February 13, 2019

Re: **Contract C1800176** – (Aladdin Plating Site Remediation Project, Tacoma, Washington)  
Final Offer Change Order 2 (Equitable Adjustment for Quantity Overruns)

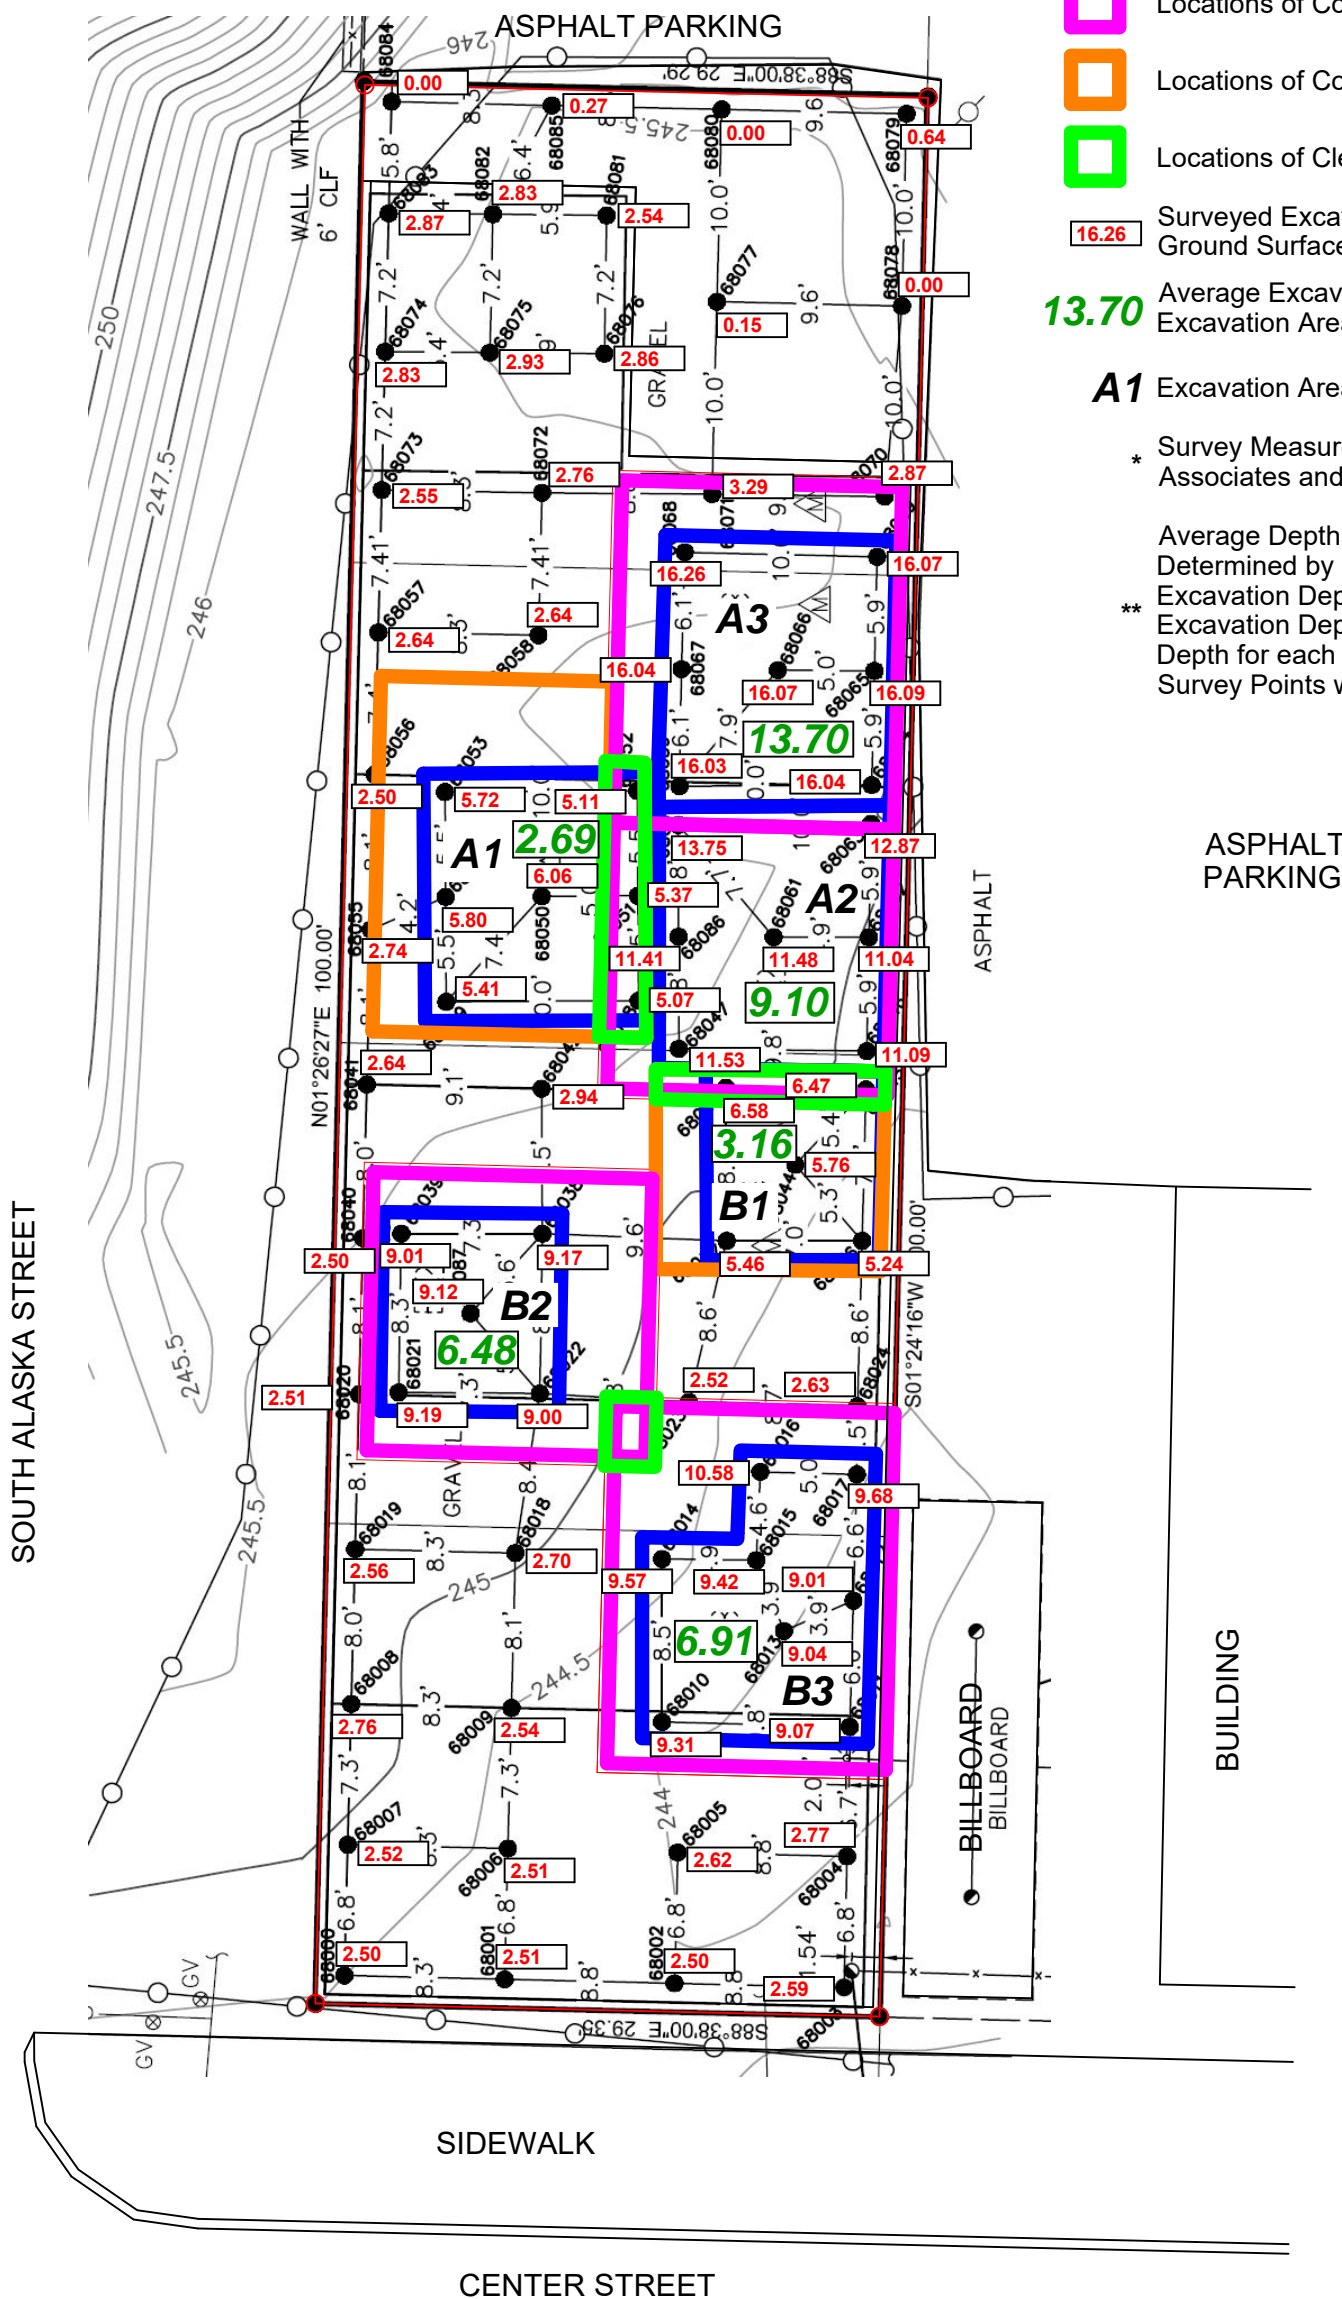
An evaluation was performed to identify the source(s) of soil that contributed to the quantity removed by 3 Kings from the site. The results of the evaluation are presented in enclosed Table 1 and on Figure 1. The evaluation has determined that all but a limited amount of the difference between the quantity specified in the Project Manual (330 tons) and what was disposed of by 3 Kings (620 tons) was due to the actual volume of material removed by 3 Kings as extra excavation for installation of shoring and sloping that 3 Kings elected to use for the project.

As shown in Table 1 and on Figure 1, the extra excavation performed by 3 Kings for sloping and to install the shoring 3 Kings elected to use includes the following:

- Extra excavation consisting of sloping of un-shored excavations at remediation areas A1 and B1.
- Extra excavation resulting from the surface area encompassed by the shoring 3 Kings elected to use for excavation at areas A2, A3, B2 and B3.
- Extra excavation due to 3 Kings methods used to install the shoring used for the project.
- Extra excavation that included re-excavation of soil backfill at areas A1, B1, and B3 as a result of the overlapping surface area encompassed by the shoring 3 Kings elected to use.
- Extra excavation where 3 Kings dug to a depth greater than specified in the Project Manual.

The volume of subsurface soil excavated by 3 Kings that is attributable to the extra excavation described above and presented in Table 1 and on Figure 1 totaled 167 cubic yards. The tonnage of subsurface soil excavated by 3 Kings that is attributable to extra excavation based on the density of soil utilized in the Project Manual (1.5 tons per cubic yard) is 250 tons. The quantity of soil removed by 3 Kings as extra excavation (167 cubic yards/250 tons) was an increase of 76% over the quantity specified in the Project Manual (220 cubic yards/330 tons), not 20% as stated in 3 Kings' CO-2. The costs associated with a 76% increase in the soil quantity attributed

to 3 Kings' extra excavation is included in Pay Item M. Therefore, no additional Contract Sum or Contract Time is warranted for 3 Kings' extra excavation.

Pay Item M also specifies that the contractor shall supply an equal quantity of backfill to replace soil removed as a result of extra excavation. Therefore, no additional Contract Sum or Contract Time is warranted for 3 Kings' for backfilling the areas of extra excavation.
